Agenda Date: <u>11/08/2016</u> Agenda Item: <u>4.1</u>

STAFF REPORT

SUBJECT: Duarte Ranch Subdivision 9027 Design Review (DR 16-16)

Proposed Master Plotting Plan

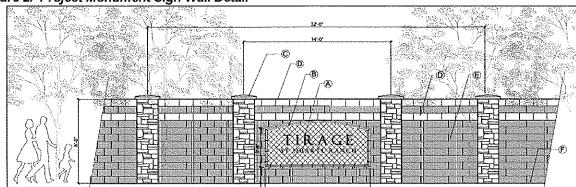
The Master Plotting Plan shows a specific plan type on each lot, as well as the expected setbacks to property lines and distance between adjacent homes. Plan1 (the one-story) makes up 30 of the total homes; Plan 2 – 18; Plan 3 – 20; Plan 4 – 17 and Plan 5 – 15. Since there are 100 proposed homes, the total number also represents the respective percentage. There are 18 corner lots in Units 1 and 2, and 12 of them are plotted with Plan 1 (the one-story). The plotting plan shows no instance where two of the same floor plan are adjacent to each other and few instances where the same floor plan is directly across the street from one another.

Staff analyzed the variation in setbacks for front yards and between two-story elements of adjacent homes on side yards. The applicant has plotted all of the homes so that the minimum front yard setback of 20 feet is rarely exceeded by the living area. Only meeting the required front minimum setback results in maximized rear yards. While the living areas of the homes are proposed at similar setbacks to the street, the front porches do provide some variation in the distances to the street due to different home footprints. Also, Plan 4 (with the side-loaded garage) provides a completely different streetscape and much further setback to the house entry. Even with the above positives, Plans 1, 2, 3 and 5 all have a similar distance between the living area and garage door. In order to maintain setback variations between the front doors, the homes would need to be plotted so the minimum front yard setback of 20 feet is exceeded in some cases. Staff has included language from the Residential Design Guidelines in the Conditions of Approval that reads as follows (language slightly modified to apply to the project):

between adjacent second stories. With the exception of the one-story homes, all houses are a minimum of 15 feet from each other on the side yards. Since the guideline applies to the second story, the proposed Master Plotting Plan implements it where applicable.

Building mass is an element of lot siting and design. The covered porches, projecting architectural elements, and varying roof plans within the same footprints all add to the diversity of the house styles. As previously described, 12 of the 18 corner lots are plotted with the one-story Plan 1, resulting in compliance with the guidelines where at least 50% of corner lots are one-story homes. The guidelines also call for at least 25% of the homes being one-story. At 30% one-story homes (30 of 100 homes), the project complies with this guideline as well.

- 11. Not more than two (2) adjacent homes shall have the same front setbacks to the living area.
- 12. For each group of three (3) adjacent homes, at least one (1) home shall have a front yard setback to the living area that varies from both the other two homes by at least five (5) feet.
